City of Sydney

Environmental Assessment for Sydney CityGrid Stage 2D

Thank you for the opportunity to comment on the Energy Australia Stage 2D project which involves the construction of the City East Cable Tunnel (CECT), refurbishment of the existing Dalley Street substation, extension of City South Tunnel (CSCT) and associated ancillary works.

Sydney CityGrid Project – (Application: 08_0075)

Figure 6-4 Indicative layout of Riley Street construction compound

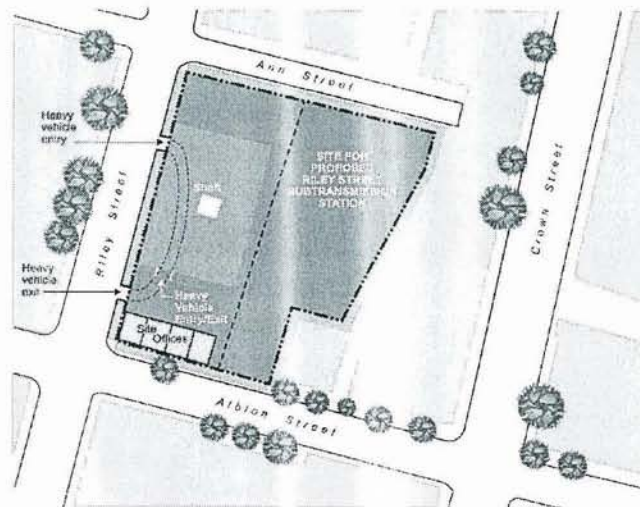
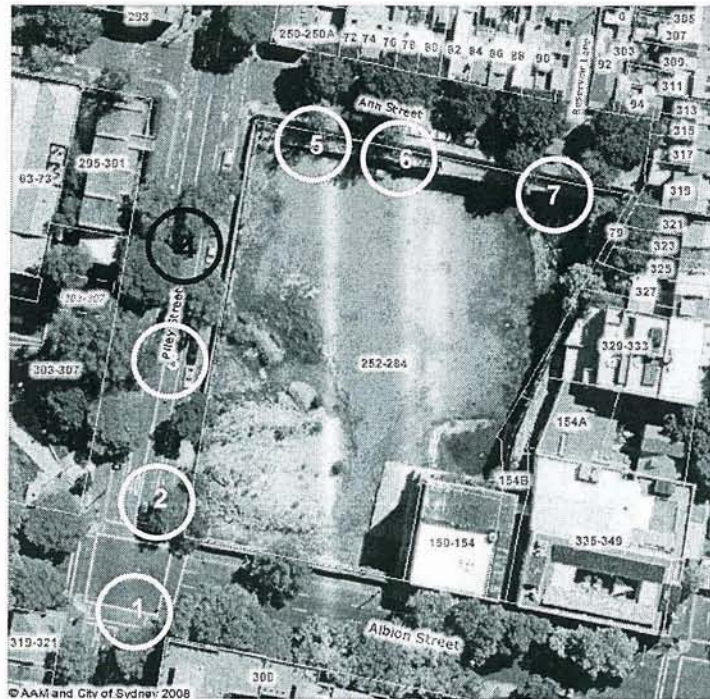
This site is bounded by four (4) mature street trees located along the Riley St frontage, and three (3) other mature street trees are located along the Ann St frontage. These trees are not indicated on the indicative plan within the Energy Australia Environmental Assessment dated November 2010, as shown below, and there is no clear intention in the document whether the applicant intends to remove or retain these trees. Council has provided an aerial view of the site, below for reference, with the trees highlighted.

The street tree numbered 4 and circled in black above is in poor condition and may be removed if it is in conflict with the proposed vehicle entry point. Other trees circled in green are of medium-high retention value and must be retained.

- A number of trees have established within the Riley St site since it has been vacant. These trees are a range of species that have self seeded and should not be considered a constraint to the development.
- Any proposed tree removal is clearly detailed within appropriate plans and documentation, and that the City of Sydney is advised of any proposed tree removal at the earliest opportunity.
- The applicant is required to notify the community at the earliest opportunity of any proposal to remove street trees.
